BID PACKAGE 02 – ADDENDUM 01**Date:** January 10, 2020**Re:** Wilma P Mankiller Health Center Expansion**From:** James R Childers Architect, Inc.
45 South 4th Street
Fort Smith, Arkansas 72901

CHANGE NARRATIVE LETTER

TO: MATHEW THOMAS- CHILDERS ARCHITECTS
FROM: STEPHEN EDMONDSON, TREY SMITH, BETSY WELLS– HP ENGINEERING, INC.
DATE: 1/10/2020
PROJECT: WPMHC EXPANSION BID PACKAGE 02 ADDENDUM 01

SHEET NUMBER:
A1.21

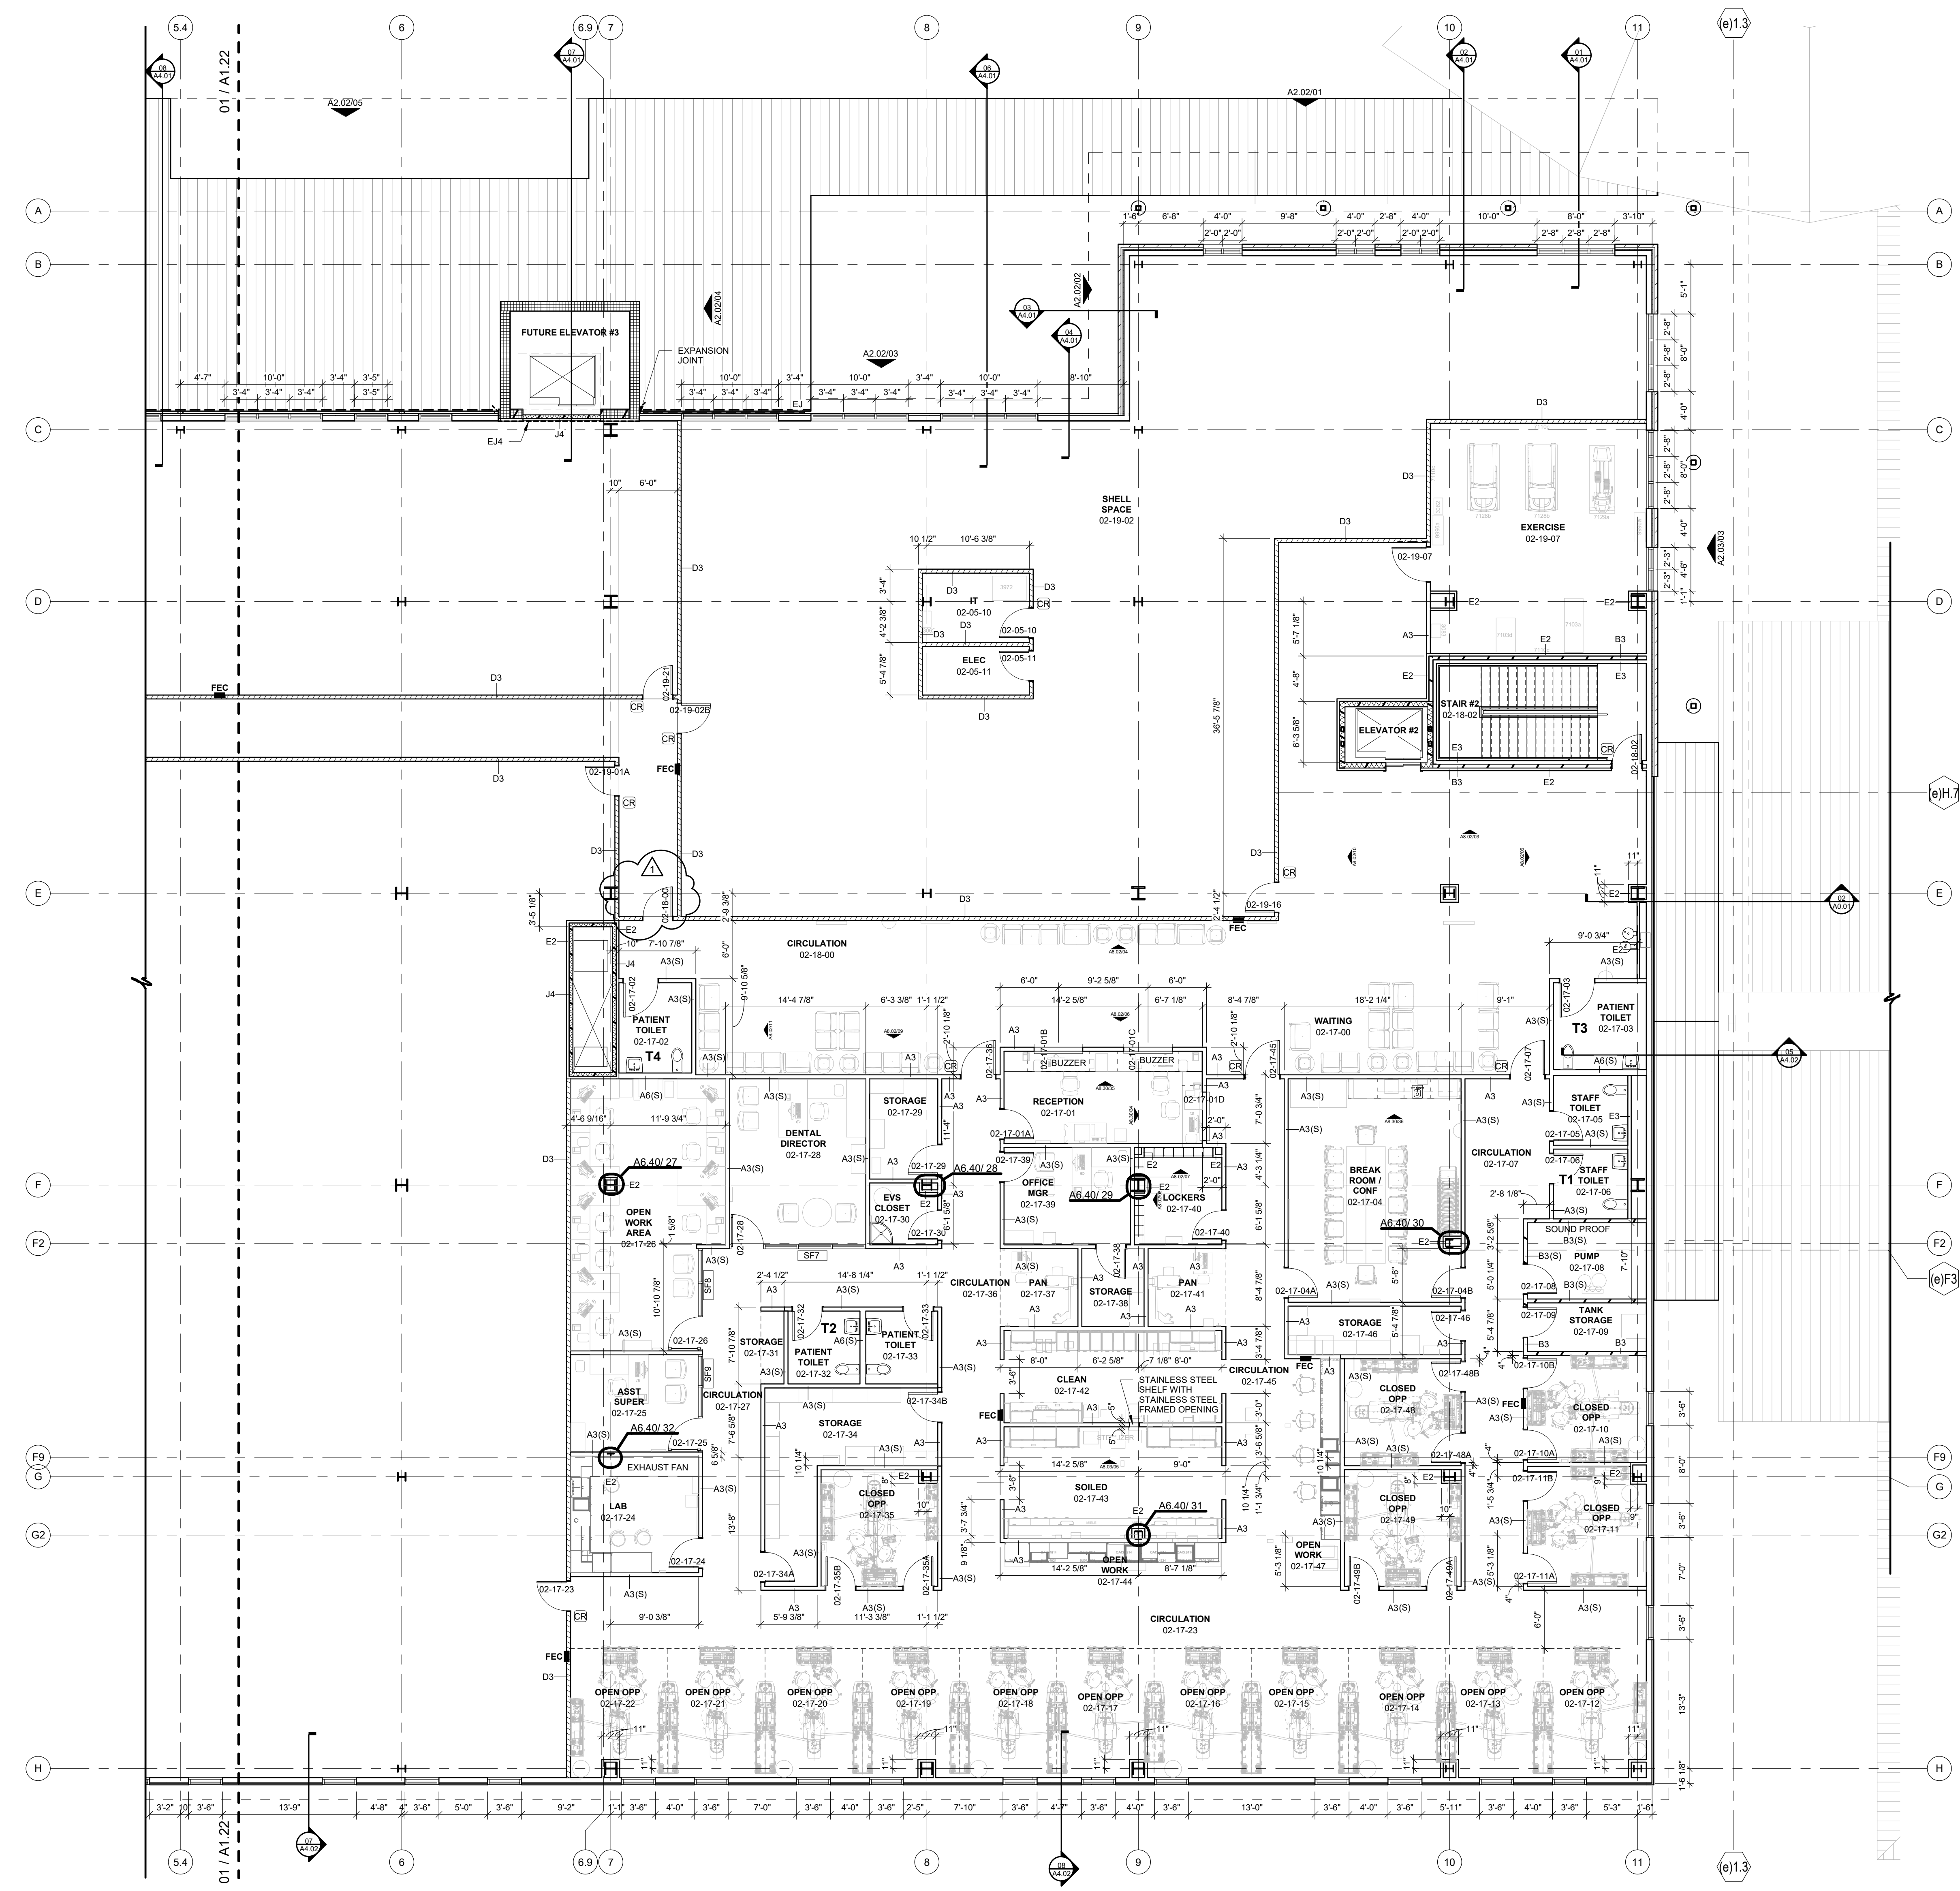
- Item 01**
- A1.21 – Added door 02-18-00
 - A1.30 – Door 03-19-01 Revised door swing.
 - A2.02 – Project phase and date revised.
 - A2.03 – Project phase and date revised.

SHEET NUMBER:
A7.13

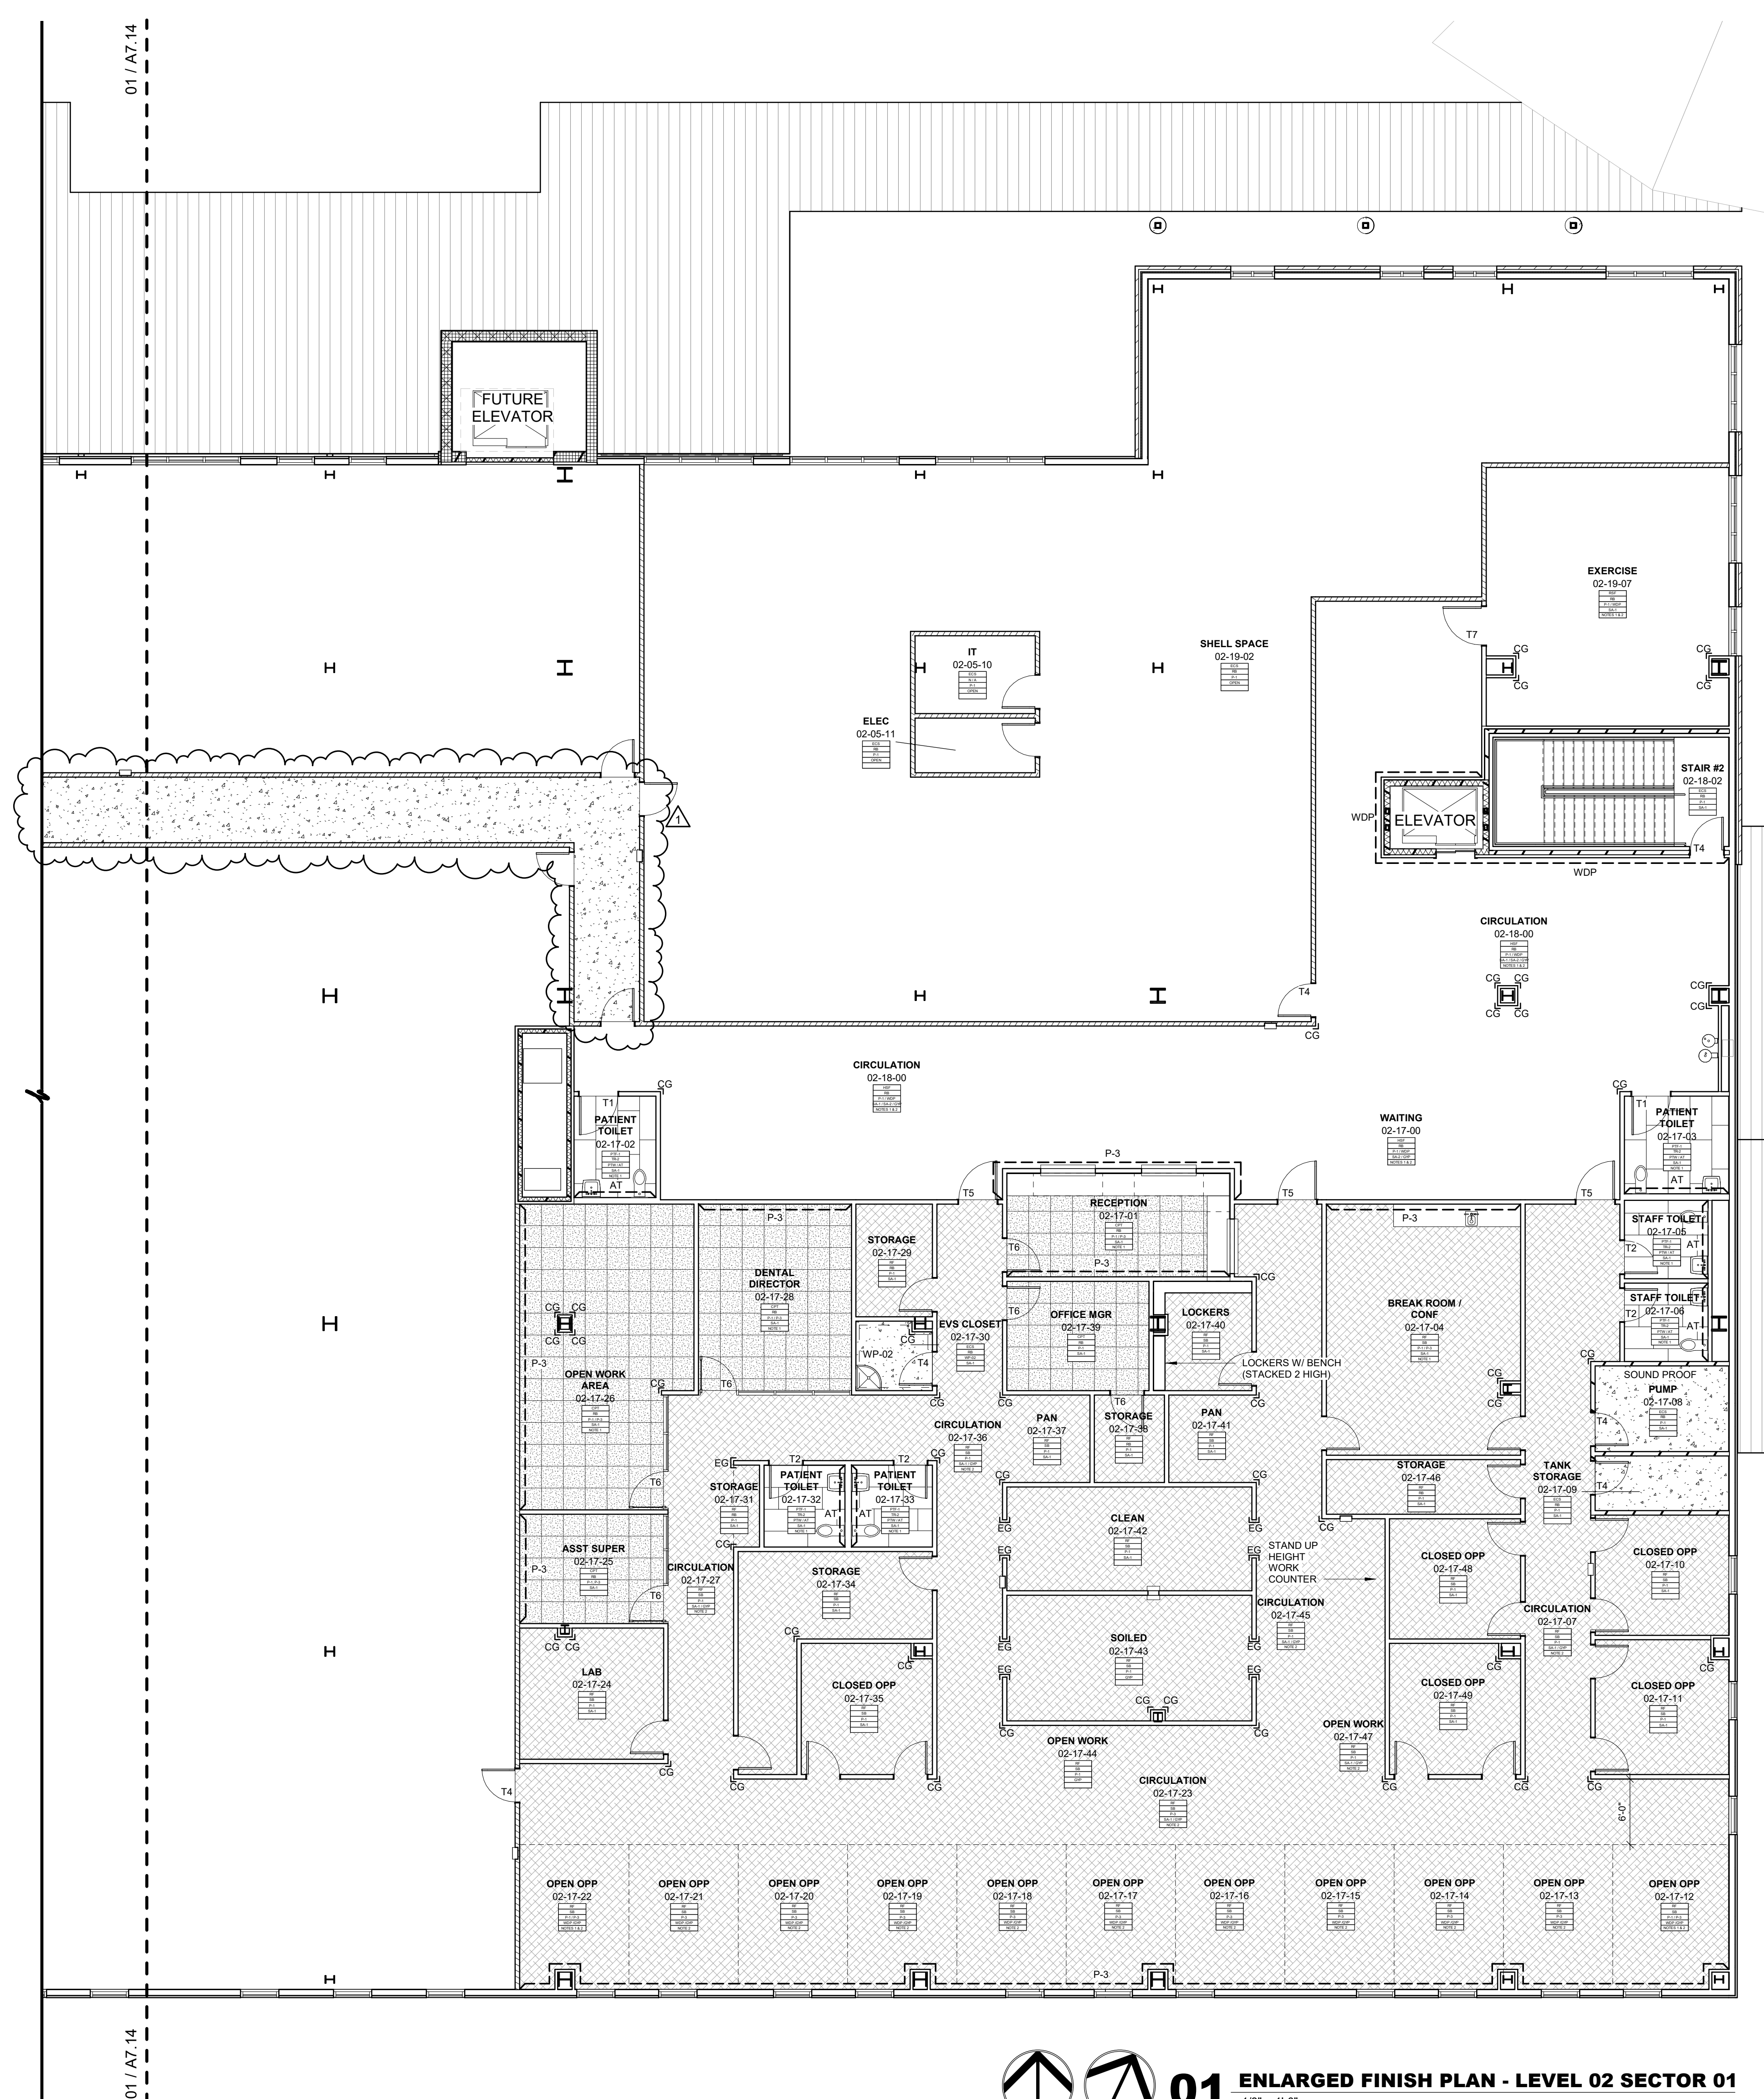
- A7.13 – Flooring changed to exposed sealed concrete in corridor.
 - A7.14 – Flooring changed to exposed sealed concrete in corridor.
 - A8.31 – Project phase and date revised.

SHEET NUMBER:
A9.21

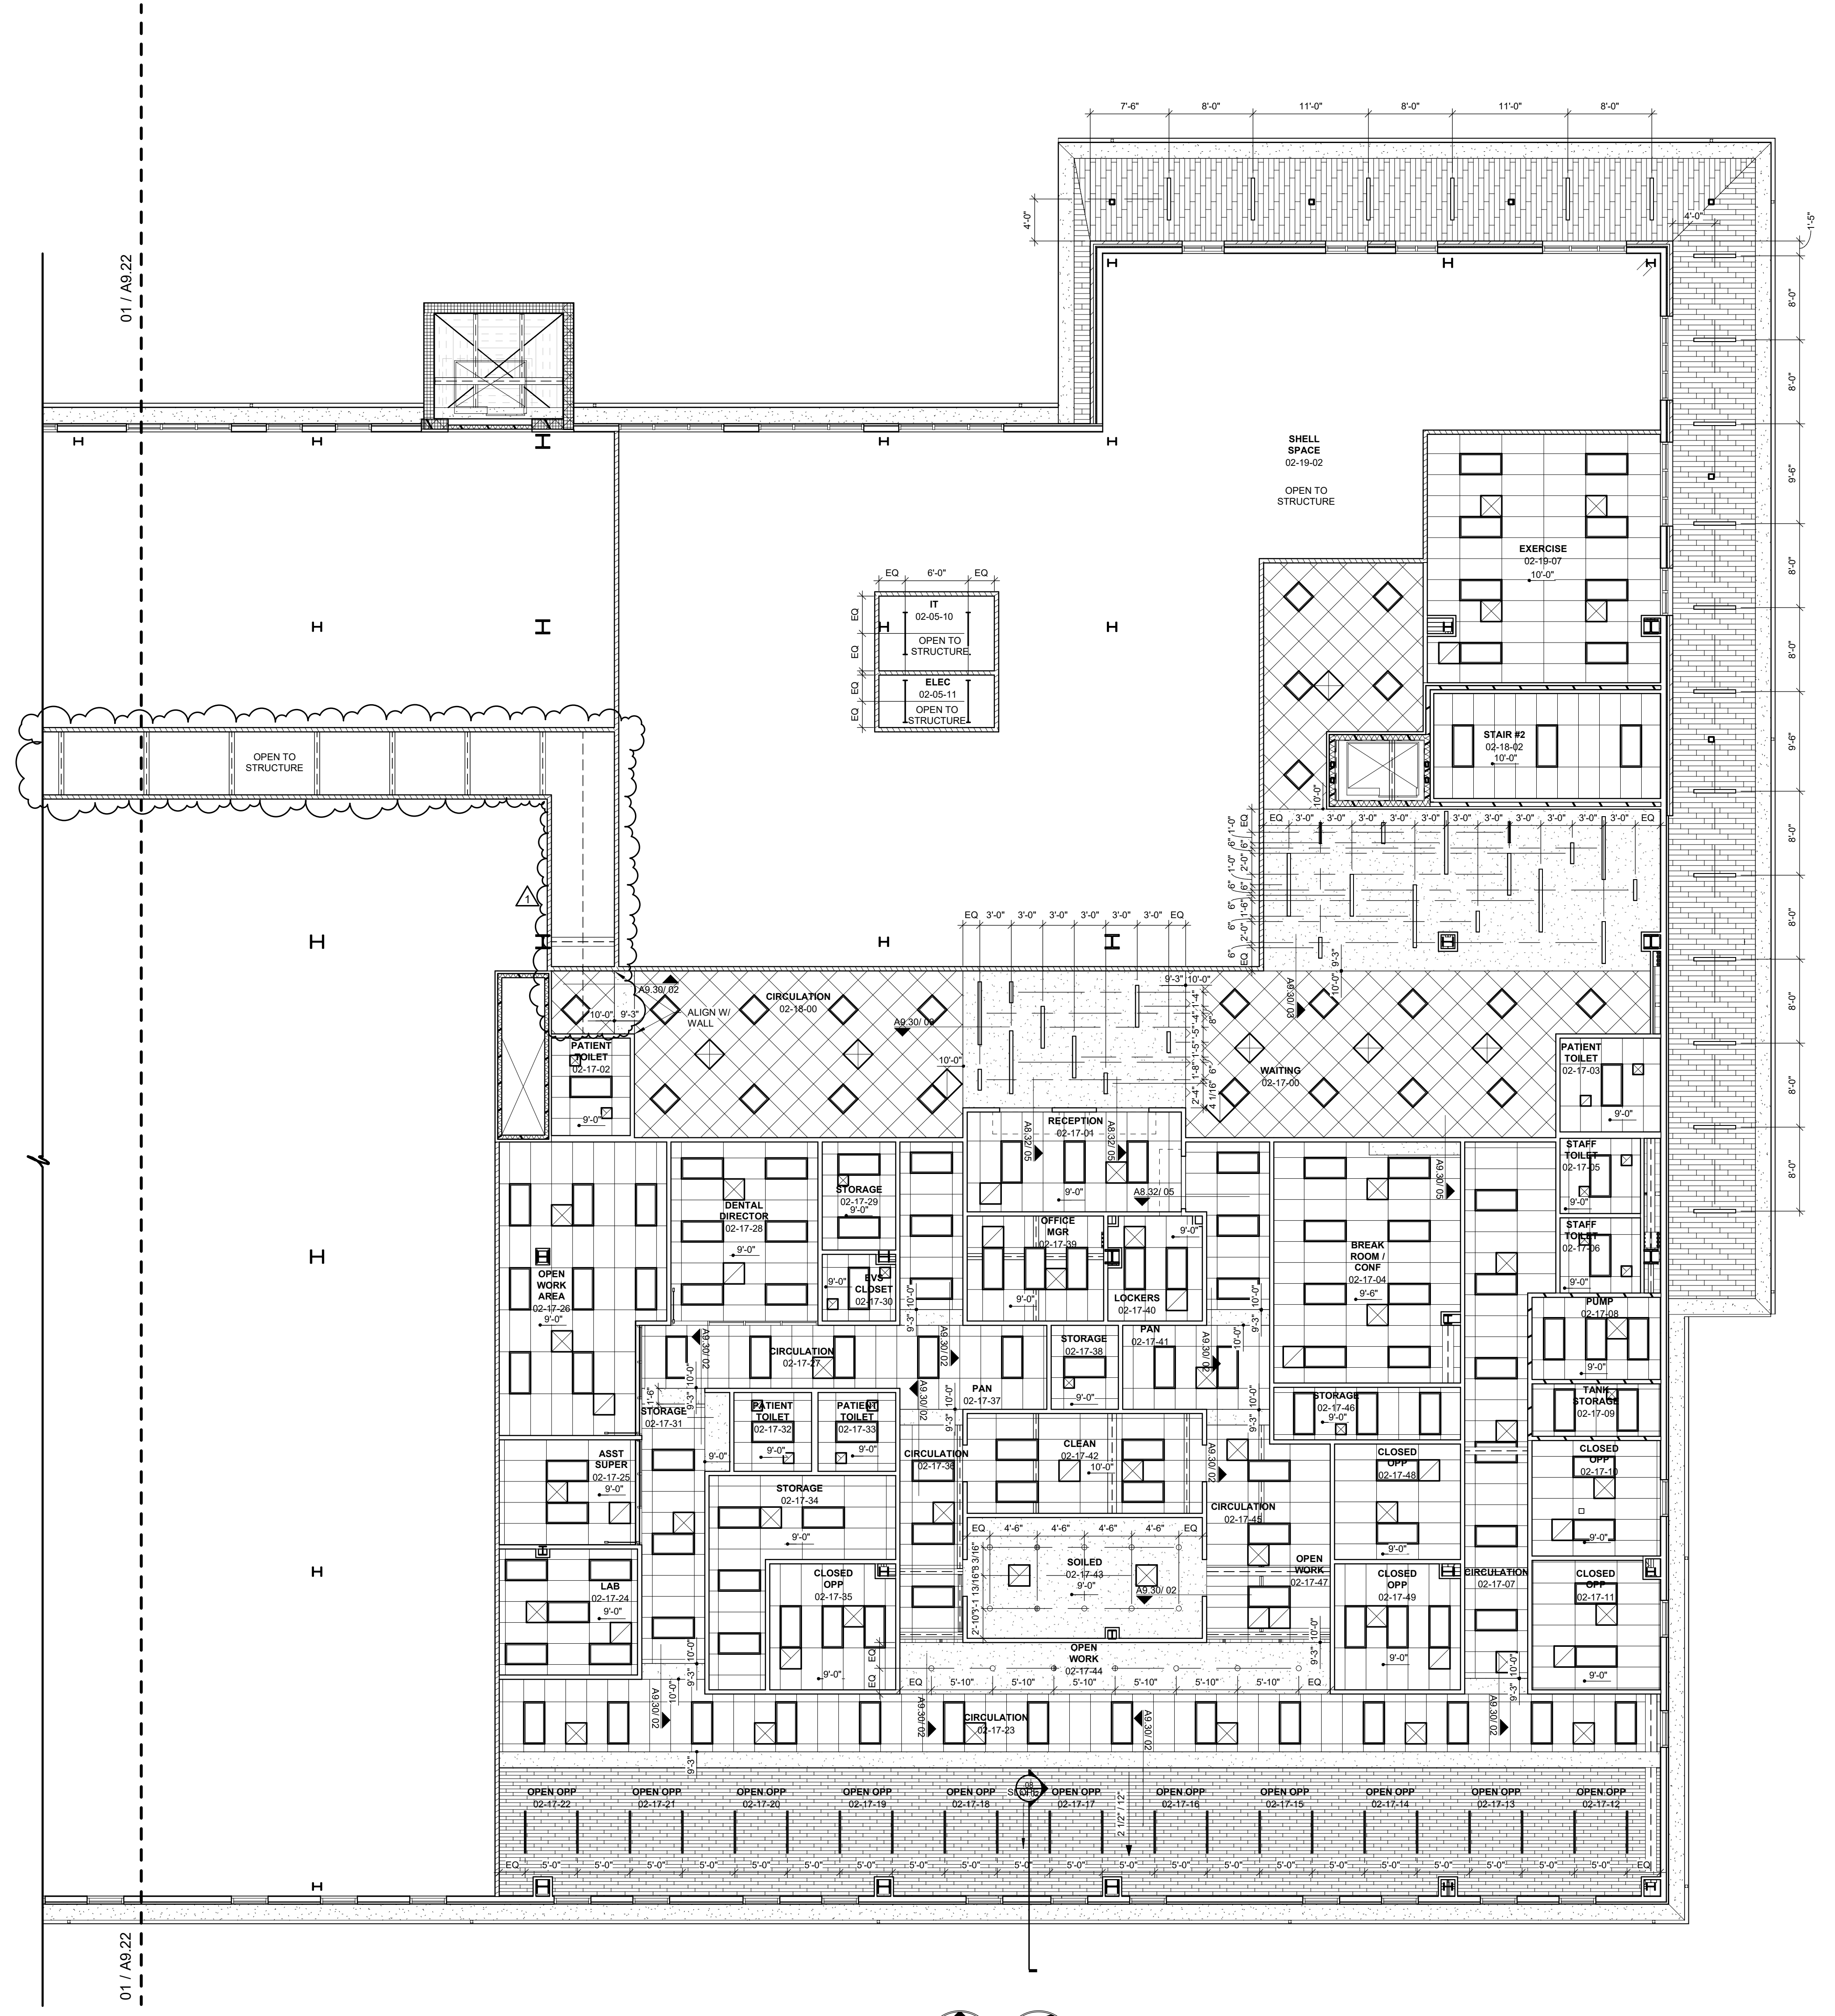
- A9.21 – Lighting fixtures taken out / Ceiling changed to open to structure.
 - A9.22 – Lighting fixtures taken out / Ceiling changed to open to structure.
